**RE: PLANNING PROPOSAL 2016/7/A  
45 VICTOR STREET AND 410-416 VICTORIA AVENUE, CHATSWOOD**

# Response to Council letter dated 28 October 2020 and amended Planning Proposal

Figure 2.2.3 of Council’s CBD strategy

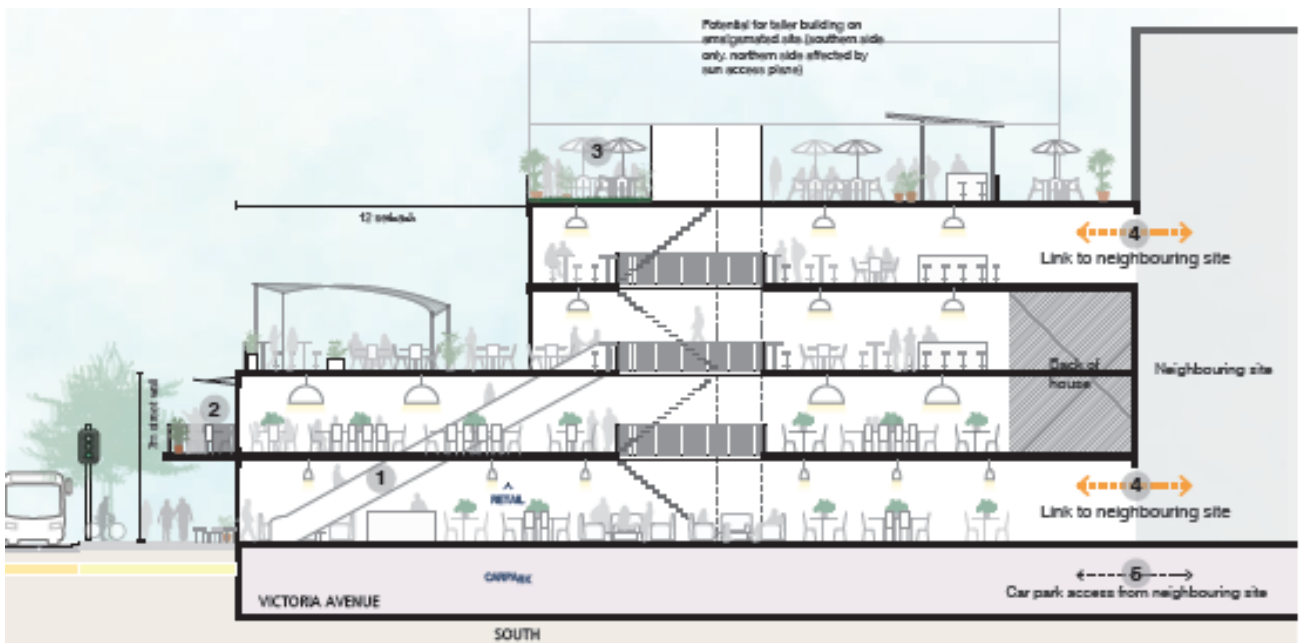
In stating that “the proposal satisfies all suggested building height requirements” the Proponent is suggesting that, with regard to the Victoria Avenue street wall height, the Proposal satisfies the intent of the control rather than the specific height prescribed. The intent is understood to be a desire for a two-

The Proposal comprises a two-storey frontage to Victoria Avenue in accordance with Figure 2.2.3 in Council’s CBD Strategy (see below), which envisages generous publicly accessible tenancies and activated rooftop terrace spaces.

**POS - Long Section**

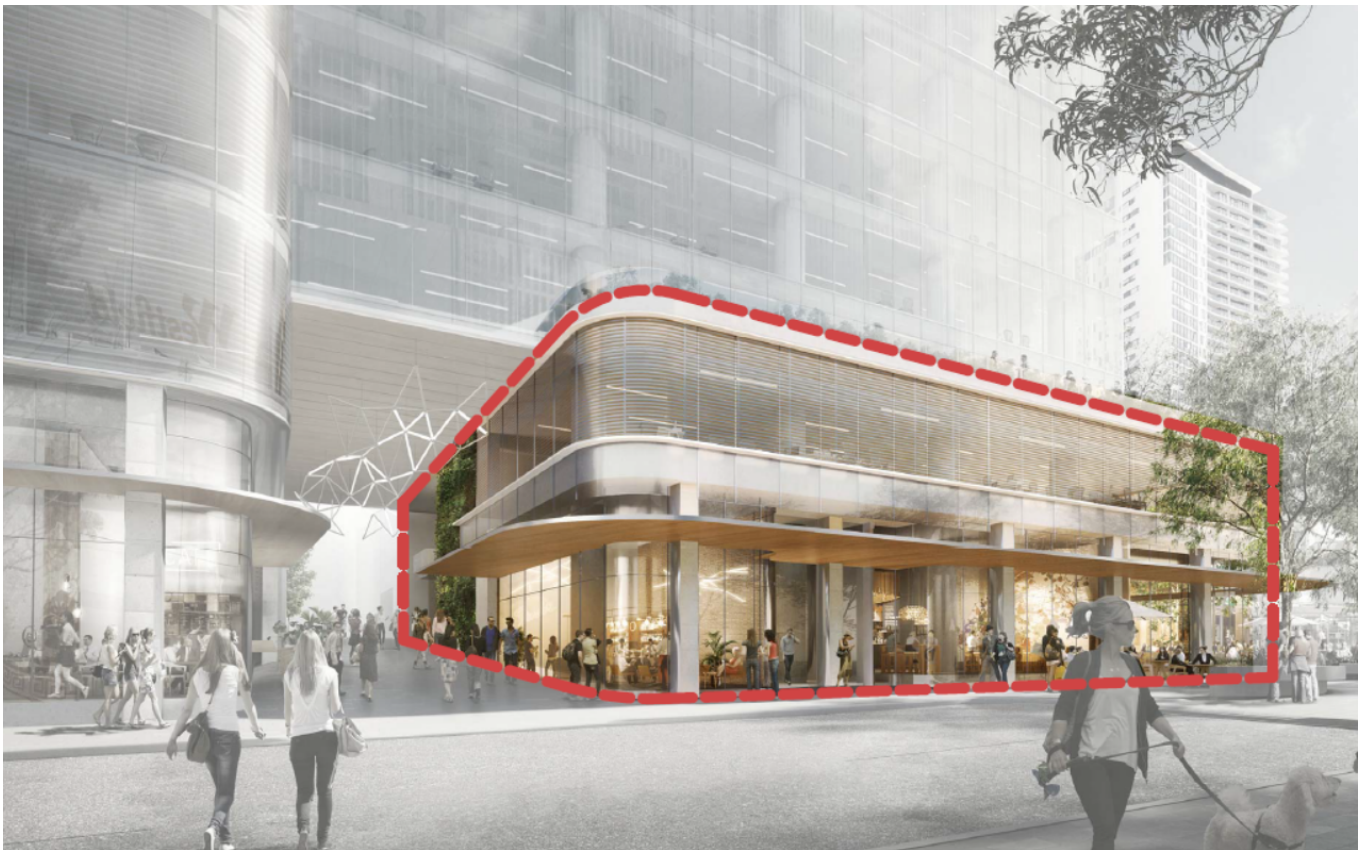
Analysis is required to clearly identify how the requirements in Figure 3.1.7 have been addressed, with particular regard to the loss of an existing 24 hour through site link and the replacement with a covered link. How is this space to be managed and public access guaranteed?

The ceiling height within the laneway is consistent with the height of the podium along Victoria Avenue and the northern end of Victor Street, enabling the scale of the two-storey podium street wall to carry through and define the scale of the laneway.
